**City of Glendale
Community Development Department
Design Review Staff Report – Single Family**

Meeting/Decision Date: November 7, 2019	Address: 4320 Maryland Avenue
Review Authority: <input type="checkbox"/> DRB <input checked="" type="checkbox"/> ADR <input type="checkbox"/> HPC <input type="checkbox"/> CC	APN: 5606-010-032
Case Number: PDR1914508	Applicant: Mi Kyung Jung
Prepared By: Minjee Hahm, Planning Associate	Owner: Rara Kang and Brian Hjelle

RARA KANG RESIDENCE ADDITION

1 PROPOSED FLOOR PLAN
SCALE: 1/4" = 1'-0"

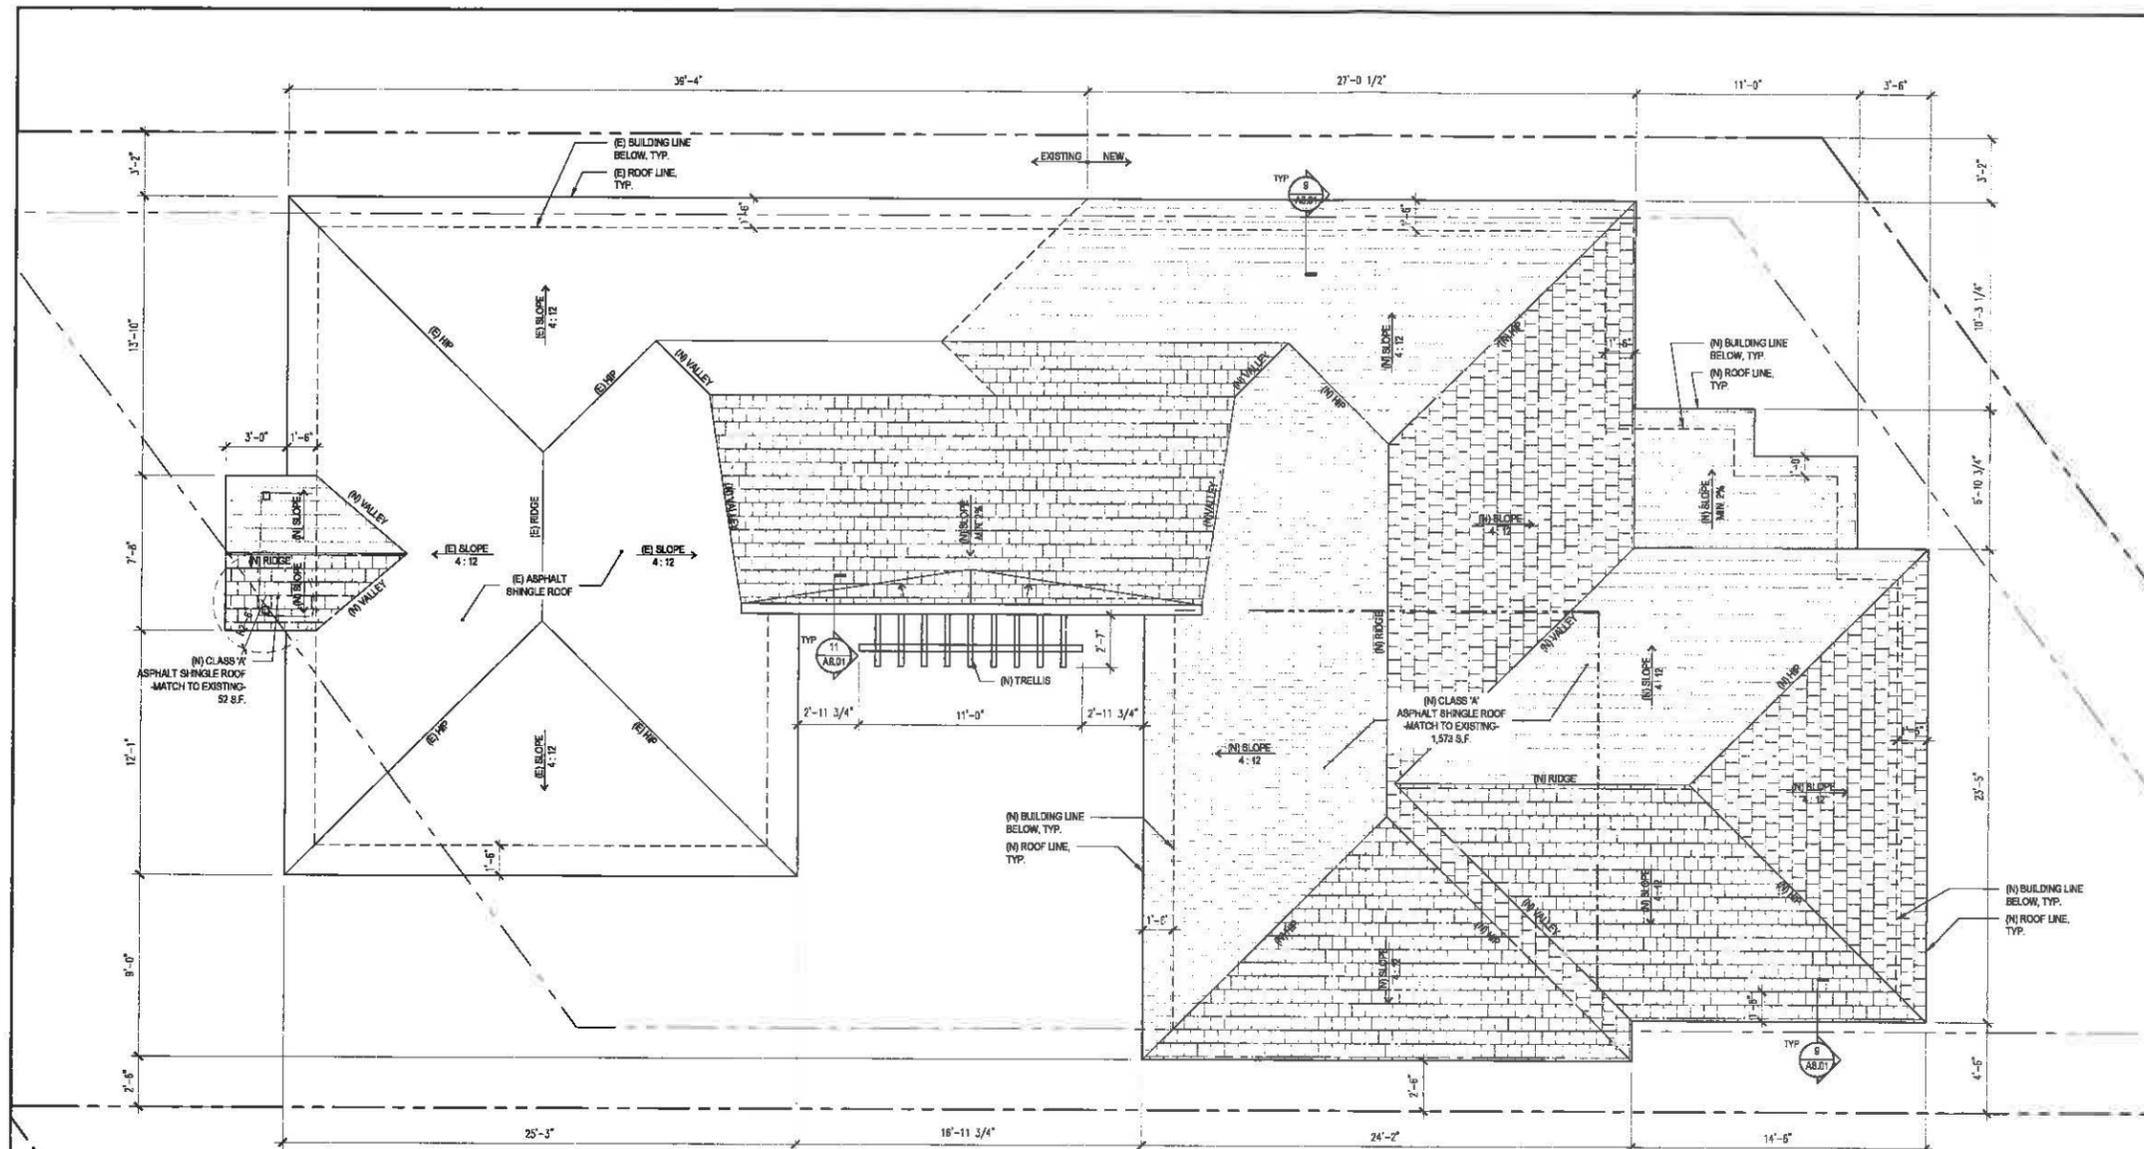
The proposed addition to the rear and the new garage are appropriately sited and meets setback requirements. The existing covered front entry will be demolished and replaced to have a gabled roof form. However, the proposed covered front entry is located in the front setback area of 25 feet. Since posts for covered entryways are not permitted in the front setback area, it will have to be relocated. To accomplish this, the projection of the entire porch roof must be decreased to address the setback issue while also allowing the porch to have a balanced and proportional design. As a condition of this approval, the porch will be redesigned to meet the setback requirements and provide a balanced, proportional design.

The existing covered front entry will be demolished and replaced to have a gabled roof form. Since the rest of the dwelling will maintain hipped roof forms, the gabled entryway will be emphasized and create visual interest. However, the proposed covered front entry is located in the front setback area of 25 feet. Since posts for covered entryways are not permitted in the front setback area, it will have to be relocated. To accomplish this, the projection of the entire porch roof must be decreased to address the setback issue while also allowing the porch to have a balanced and proportional design. As a condition of this approval, the porch will be redesigned to meet the setback requirements and provide a balanced, proportional design.

4. The covered front entry will be redesigned to meet the setback requirements and provide a balanced, proportional design.
5. The protected oak tree shall remain inaccessible to all construction activity. The proposed project will require an Indigenous Tree Permit, which can be obtained from Forestry during plan check.

RENDERED
 PERSPECTIVE

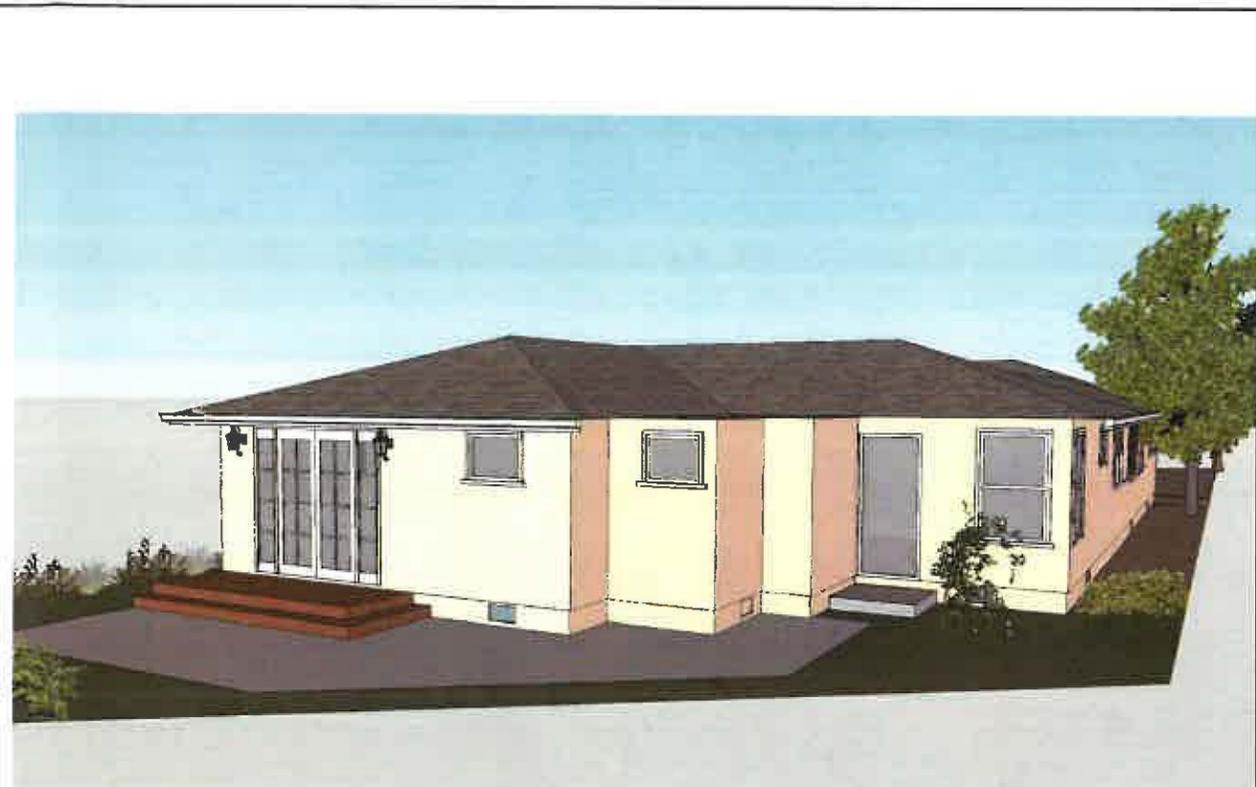
While the rendered perspective shows recessed placement for both the existing and proposed windows, the proposed elevations and window schedule do not clearly indicate the recess. As a condition of this approval, the proposed windows will be constructed with recessed placement to match the rendered perspective with wooden sills and trim. Revised elevations showing existing sills and trims to remain and a vertical window section shall be required prior to plan check submittal.

The proposed plans and rendered perspective do not show the locations of existing and proposed gutters and downspouts. As a condition of this approval, existing and proposed locations of the gutters and downspouts will be provided on revised plans for staff review and approval prior to plan check submittal.

1. Revise plans and rendered perspective to show existing and proposed locations of gutters and downspouts for staff review and approval prior to plan check submittal.

2. Proposed windows are to be constructed with a recessed placement to match the rendered perspective with wooden sills and trim. Revised elevations clearly showing recessed placement for existing and proposed windows and a vertical window section drawing of the windows placed into the walls shall be provided prior to plan check submittal.

BUILDING ELEVATIONS

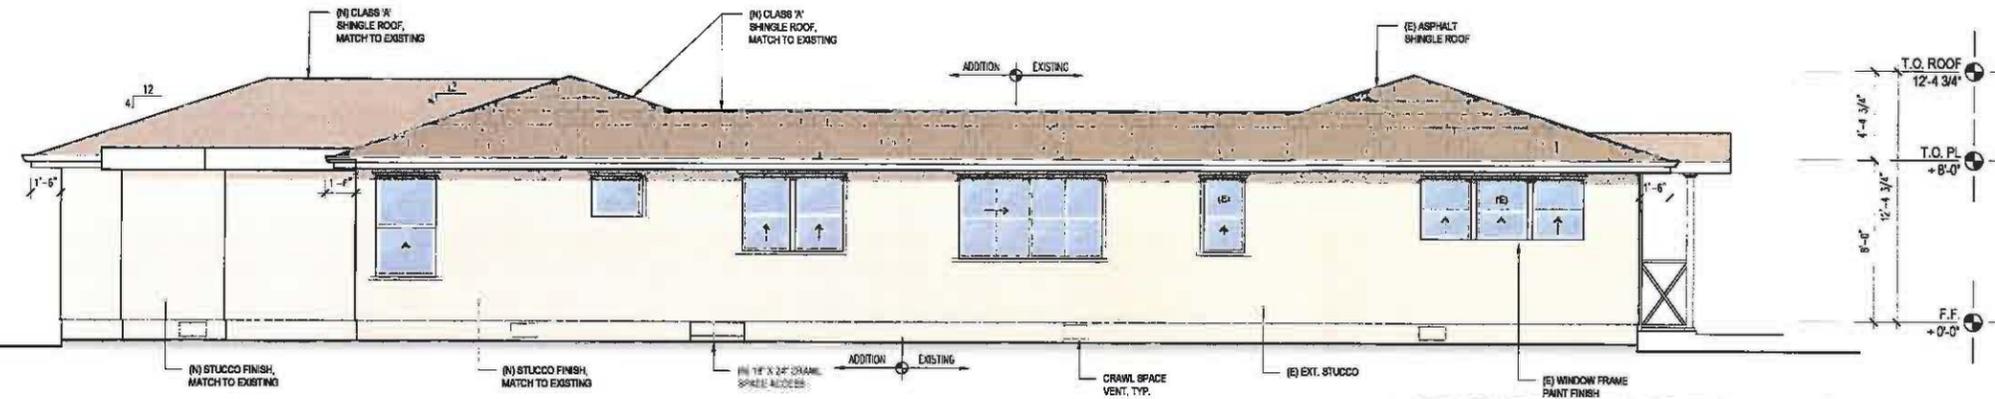
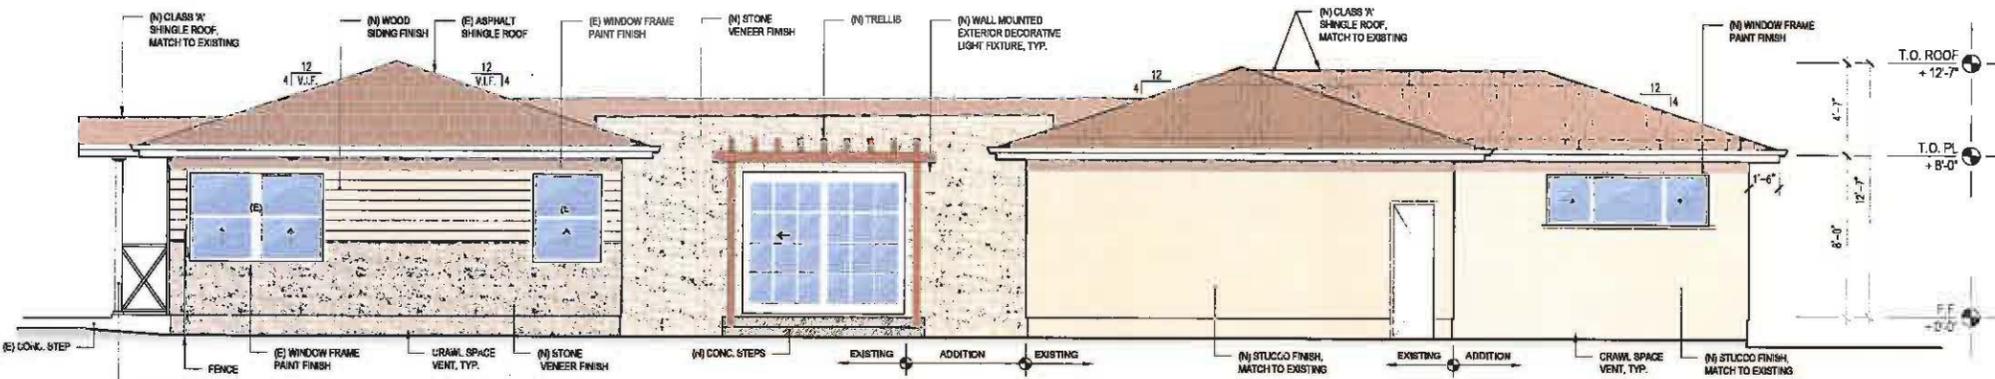
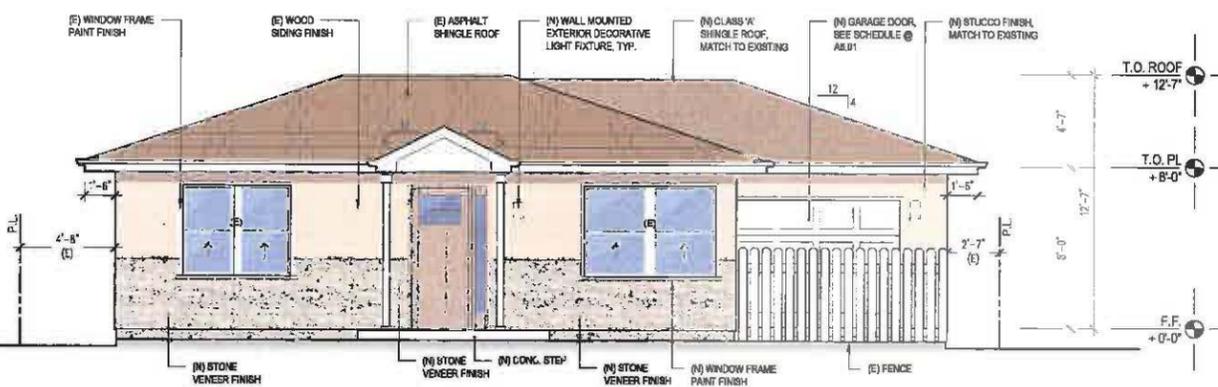
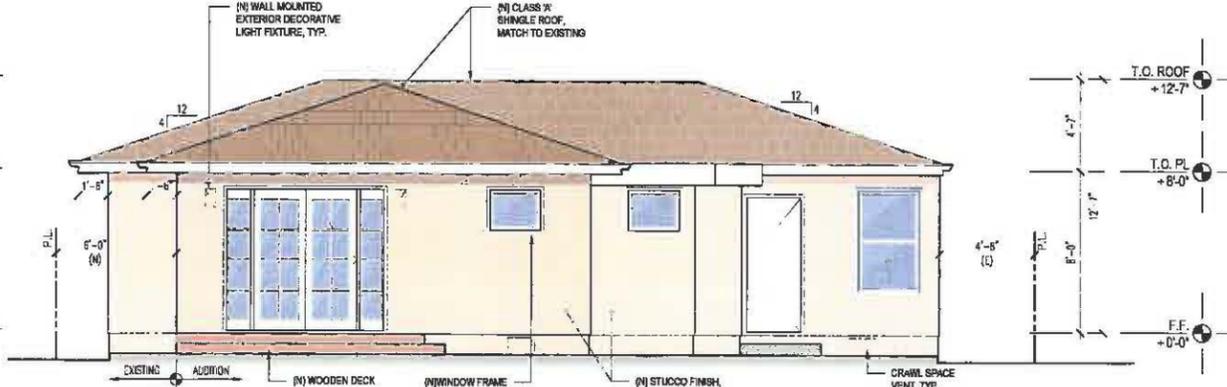
Color and materials for the addition include asphalt roof shingles; light-colored stucco; and light-colored wooden siding and faux stone veneer band applied at the street and southern interior facing façades. The faux stone veneer base band proposed to be applied at the street and southern interior facing façades is conditioned to be lowered to meet at the bottom of the existing wood sills.

- While the rendered perspective shows recessed placement for both the existing and proposed windows, the recessed placement is unclear in elevation drawings. Windows will be conditioned to be constructed with a recessed placement to match the rendered perspective with wooden sills and trim. Revised elevations showing existing sills and trims to remain and a vertical window section shall be required prior to plan check submittal.

3. The faux stone veneer base band applied at the street and southern interior facing façades will be lowered to meet at the bottom of the existing wood sills.
